PCI-SIG ENGINEERING CHANGE NOTICE

TITLE:	Process Address Space ID (PASID)
DATE:	March 31, 2011
AFFECTED DOCUMENT:	PCI Express Base Specification, Version 3.0
SPONSOR:	AMD, HP

Figure 6-20: PASID TLP Prefix

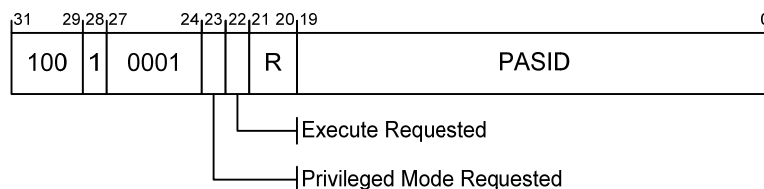
The PASID TLP Prefix is an End-End TLP Prefix as defined in Section 2.2.1. Layout of the PASID TLP Prefix is shown in Figure 6-20 and Table 6-13.

A TLP may contain at most one PASID TLP Prefix.

<u>Bits</u>	<u>Columns</u>
<u>31:29</u>	<u>100b – indicating TLP Prefix</u>
<u>28</u>	<u>1b – indicating End-End TLP Prefix</u>
<u>27:24</u>	<u>0001b – indicating PASID TLP Prefix</u>

<u>Bits</u>	<u>Columns</u>
<u>23</u>	<u>Privileged Mode Requested – If Set indicates a Privileged Mode entity in the Endpoint is issuing the Request, If Clear, indicates a Non-Privileged Mode entity in the Endpoint is issuing the Request.</u> <u>Usage of this bit is specified in Section 6.20.2.3.</u>
<u>22</u>	<u>Execute Requested – If Set indicates the Endpoint is requesting Execute Permission. If Clear, indicates the Endpoint is not requesting Execute Permission.</u> <u>Usage of this bit is specified in Section 6.20.2.2.</u>
<u>21:20</u>	<u>Reserved</u>
<u>19:0</u>	<u>Process Address Space ID (PASID) – This field contains the PASID value associated with the TLP.</u> <u>Usage of this field is defined in Section 6.20.2.1.</u>

Figure 7-138: PASID Extended Capability Structure

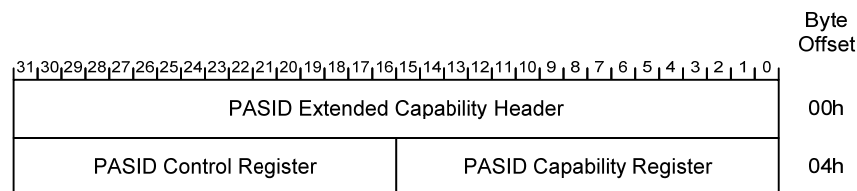
Figure 7-138 details allocation of the register bits in the PASID Extended Capability structure.

The presence of a PASID Extended Capability indicates that the Endpoint supports sending and receiving TLPs containing a PASID TLP Prefix. Separate support and enables are provided for the various optional features.

Figure 7-140: PASID Capability Register

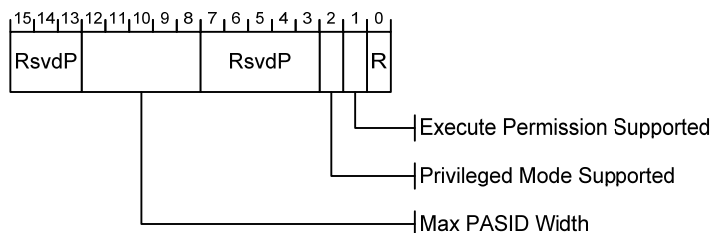
Figure 7-140 details the allocation of register bits of the PASID Capability register; Table 7-118 provides the respective bit definitions.

<u>Bit Location</u>	<u>Register Description</u>	<u>Attributes</u>
<u>0</u>	<u>Reserved</u>	<u>RsvdP</u>
<u>1</u>	<u>Execute Permission Supported</u> – If Set, the Endpoint supports sending TLPs that have the Execute Requested bit Set. If Clear, the Endpoint will never Set the Execute Requested bit.	<u>RO</u>
<u>2</u>	<u>Privileged Mode Supported</u> – If Set, the Endpoint supports operating in Privileged and Non-Privileged modes, and supports sending requests that have the Privileged Mode Requested bit Set. If Clear, the Endpoint will never Set the Privileged Mode Requested bit.	<u>RO</u>
<u>7:3</u>	<u>Reserved</u>	<u>RsvdP</u>
<u>12:8</u>	<u>Max PASID Width</u> – Indicates the width of the PASID field supported by the Endpoint. The value n indicates support for PASID values 0 through 2^n-1 (inclusive). The value 0 indicates support for a single PASID (0). The value 20 indicates support for all PASID values (20 bits). This field must be between 0 and 20 (inclusive).	<u>RO</u>

Figure 7-141: PASID Control Register

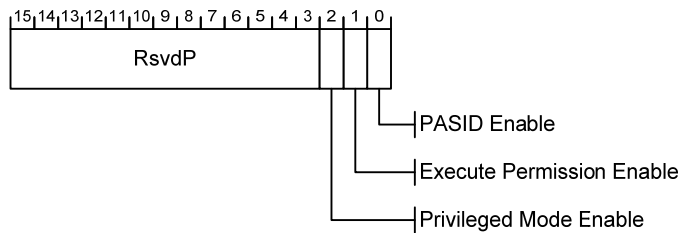
Figure 7-141 details the allocation of register bits of the PASID Control register; Table 7-119 provides the respective bit definitions.

<u>Bit Location</u>	<u>Register Description</u>	<u>Attributes</u>
<u>0</u>	<p>PASID Enable – If Set, the Endpoint is permitted to send and receive TLPs that contain a PASID TLP Prefix. If Clear, the Endpoint is not permitted to do so.</p> <p>Behavior is undefined if the Endpoint supports ATS and this bit changes value when ATS Enable (E) is Set (see the <i>Address Translation Specification</i>).</p> <p>Default is 0b.</p>	RW
<u>1</u>	<p>Execute Permission Enable – If Set, the Endpoint is permitted to send Requests that have Execute Requested Set. If Clear, the Endpoint is not permitted to do so.</p> <p>Behavior is undefined if the Endpoint supports ATS and this bit changes value when ATS Enable is Set (see the <i>Address Translation Specification</i>).</p> <p>If Execute Permission Supported is Clear, this bit is RsvdP.</p> <p>Default is 0b.</p>	RW / RsvdP (see description)
<u>2</u>	<p>Privileged Mode Enable – If Set, the Endpoint is permitted to send Requests that have the Privileged Mode Requested Set. If Clear, the Endpoint is not permitted to do so.</p> <p>Behavior is undefined if the Endpoint supports ATS and this bit changes value when ATS Enable is Set (see the <i>Address Translation Specification</i>).</p> <p>If Privileged Mode Supported is Clear, this bit is RsvdP.</p> <p>Default is 0b.</p>	RW / RsvdP (see description)
